Technical Communication	N° 24	Ed 01	Date : 18/05/2001															
Product : Alcatel Office 4200E			Nb. of pages: 3															
<input checked="" type="checkbox"/> Urgente <input type="checkbox"/> Not urgente	<input type="checkbox"/> Temporary <input checked="" type="checkbox"/> Permanent																	
Subject : NEW 4.3 SOFTWARE FOR AM 4200 E CARD																		
<p>A new version of AM 4.3 card software for Alcatel Office 4200 E has just been released. It is available under the following reference: 3AC 30304 APAA AM/AA1CB/04.3.</p> <p>An AM 4.3 migration kit is also available including the AM software 4.3 and a memory card MEB 1 M.</p> <p>This new AM 4.3 software is compatible only with Alcatel Office 4200 E Release 4.0. or later</p> <p>For this new version of AM 4.3, the AM card must be equipped with an MEB 1 M memory card (any of types MEM 1 M, DL, DL1, DL2 or DL3)</p> <p><u>Review of history of AM software:</u></p>

Appendix: Location of Reproms on the AM card

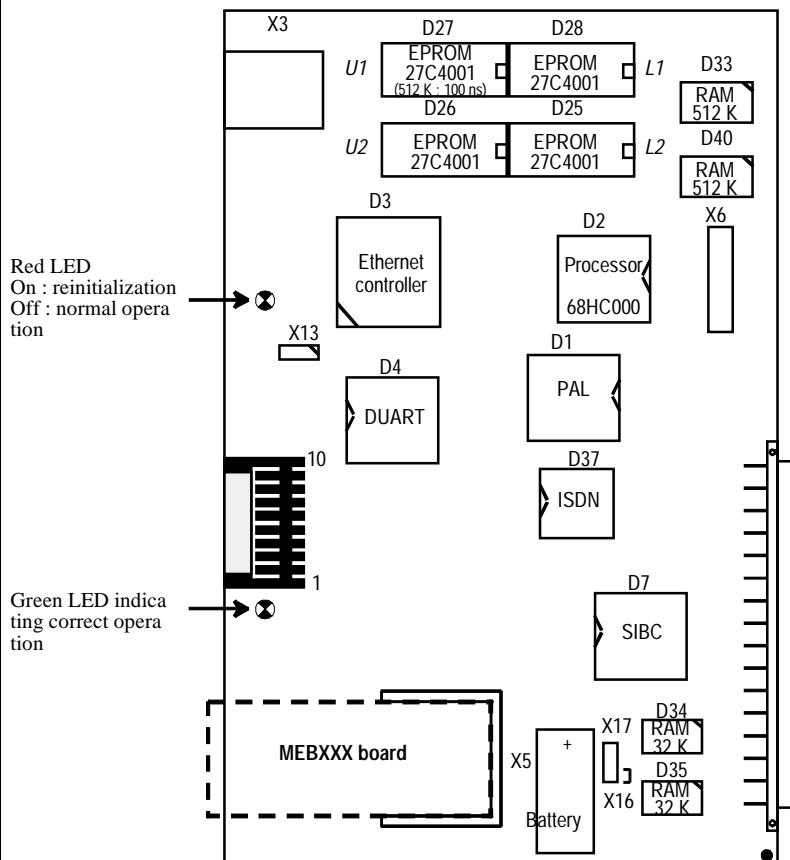
Updating is performed by replacing the 4 reproms on the AM card and adding an MEB 1M memory card (or MEBDL 1M, M1M DLx, etc.) to the AM card.

- unplug the AM card with power on
- replace the 4 reproms of the AM card (see appendix)
- plug the MEB 1M memory card into the MEM connector of the AM card
- plug the card in again with power on
- ensure that the card is operating properly with the green LED flashing: wait for slow flash 1 second ON, 4 seconds OFF

Correspondences:	Eprom D28	L1	D28	3AC 30304 APRA	checksum	C481
	Eprom D27	U1	D27	3AC 30304 APRB	checksum	9951
	Eprom D25	L2	D25	3AC 30304 APRC	checksum	B247
